SUBJECT: CATAWBA NUCLEAR STATION, UNIT 1, ISSUANCE OF EMERGENCY AMENDMENT REGARDING ONE-TIME EXTENSION OF THE AUXILIARY FEEDWATER SYSTEM AND THE CONTAINMENT SPRAY SYSTEM ALLOWED OUTAGE TIME (TAC NO. MD9226)

AMENDMENT NO. 242 TO RENEWED FACILITY OPERATING LICENSE NPF-35

CATAWBA NUCLEAR STATION, UNIT 1

Catawba Nuclear Service Water Pump

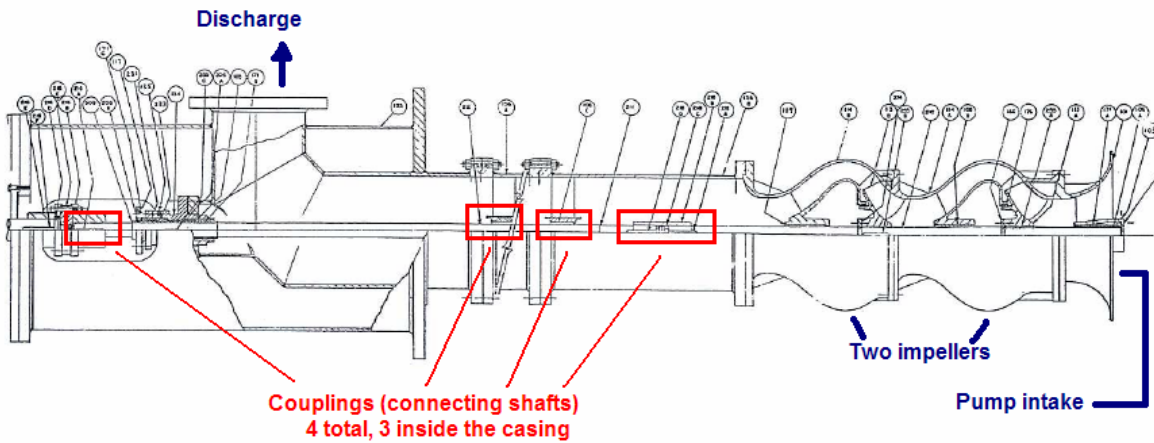
In the drawing above, the licensee has postulated that the coupling body failed and separated. The coupling body piece is 14" long and about 6.5" in diameter. Once it separated, it no longer held the split rings in place and they came off, falling down the inside of the casing and working themselves through the two impellers and ending up on the pit floor (underwater). One piece of the coupling body and both halves of the split ring were recovered by divers early morning on July 13, 2008.

The licensee's drawing below shows the pump assembly in a horizontal position, with the pump mounted vertically. The licensee believes that one of the 3 lower couplings failed and caused the shaft to drop down and leave the impeller, resting on the casing of the pump. The cause of the failure and the specific coupling that failed will be determined once the pump is removed and a failure analysis performed.

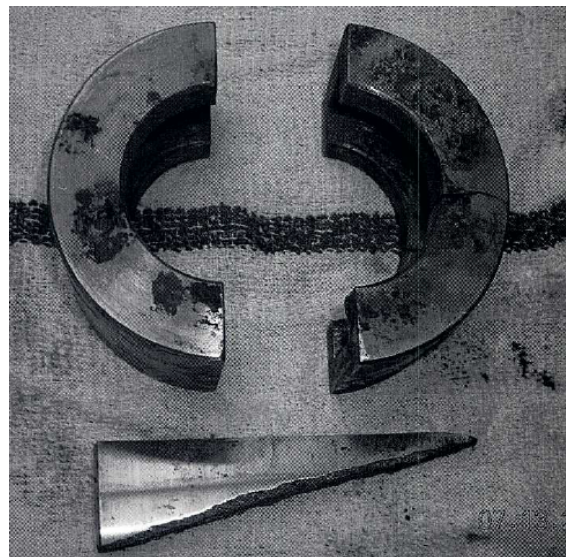
The following photo from the licensee shows the items recovered by the divers. The two rings are the split ring and the sliver is one piece of the coupling body that appears to have failed catastrophically. The licensee will perform a detailed Foreign Material Exclusion (FME) inspection once the 1B pump is pulled from the pit, to ensure that there are no pieces in the pit that could affect/damage the 1B or 2B pumps.
